## SOUTHERN SANDOVAL COUNTY ARROYO FLOOD CONTROL AUTHORITY

### *IFB# 2017-01 – BOSQUE DE BERNALILLO WATER QUALITY PROJECT*

#### **ADDENDUM #1**

**January 24, 2017**

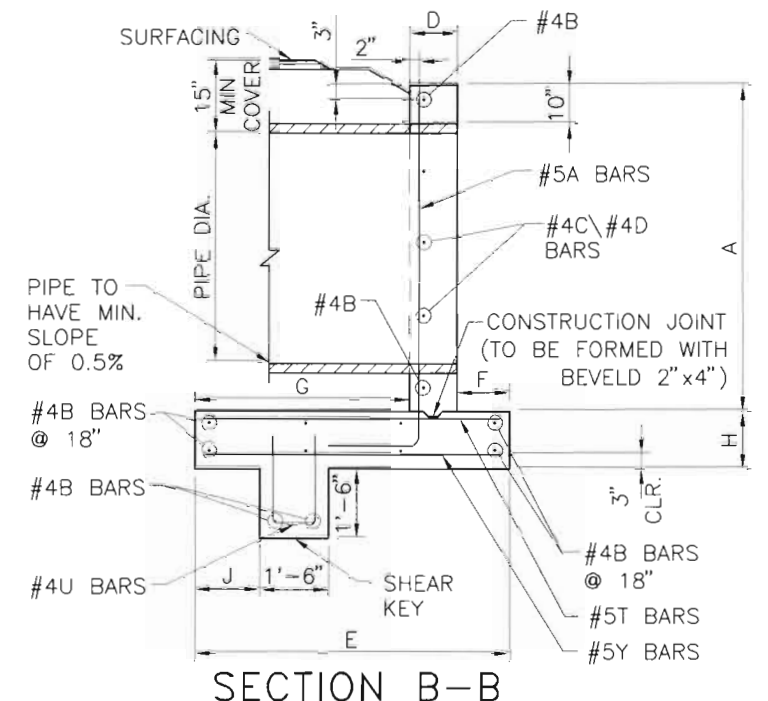
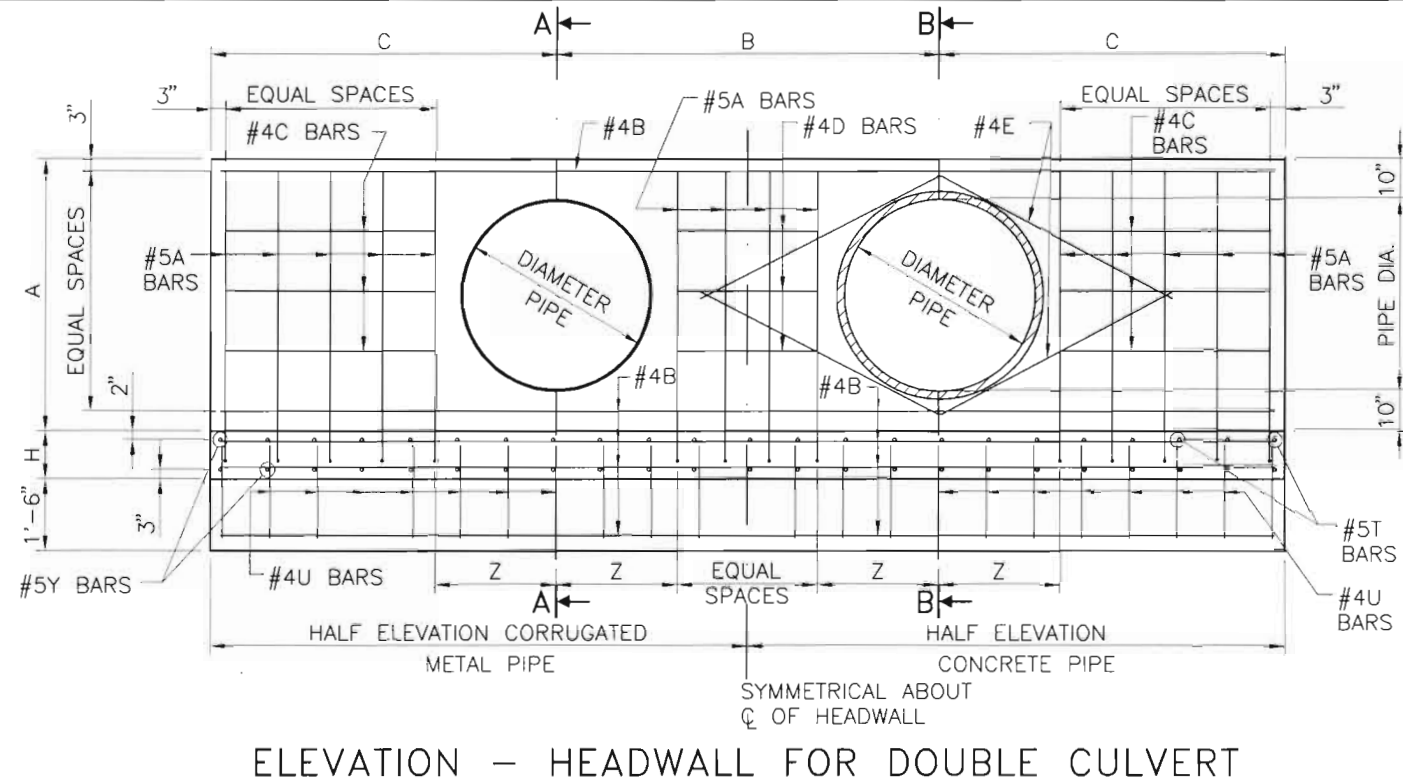
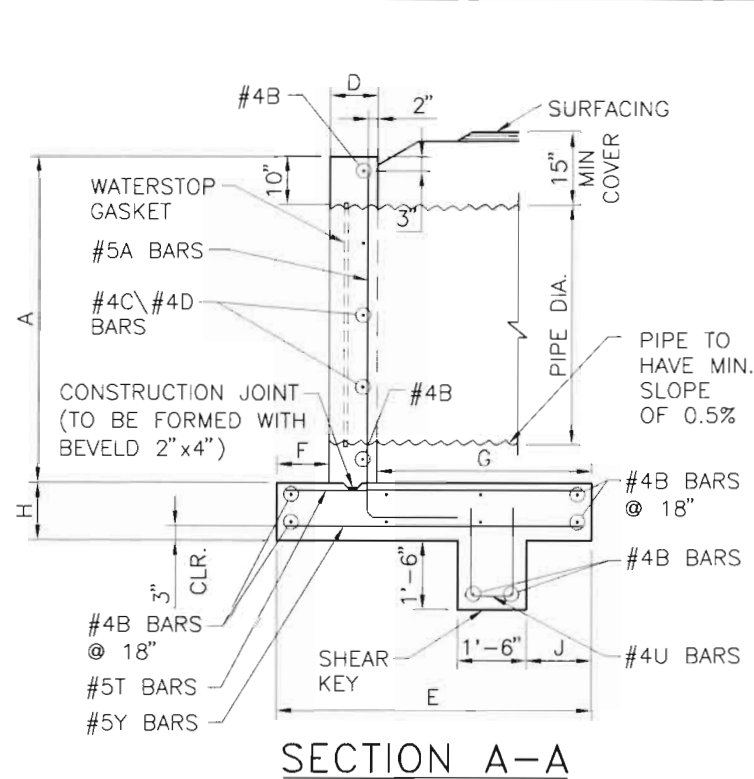
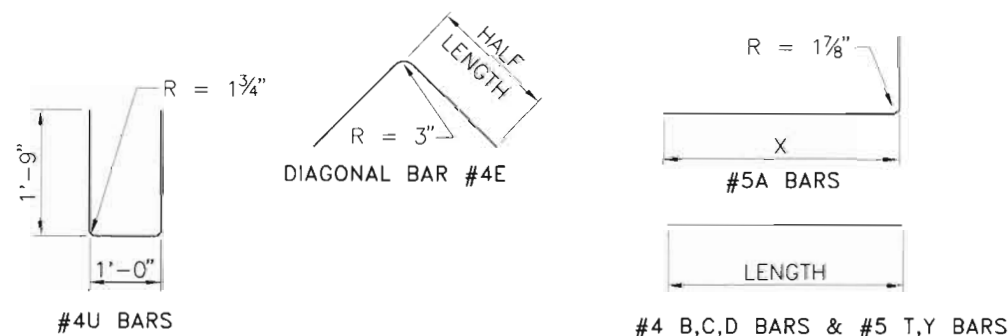
Q10: Is there a detail available for the headwalls showing dimensions and reinforcing?

**A10: The storm drain headwalls shall be installed per NMDOT Standard Drawing 511-03-1/2 and 511-03-2/2. A copy of this Drawing is attached to this addendum.**
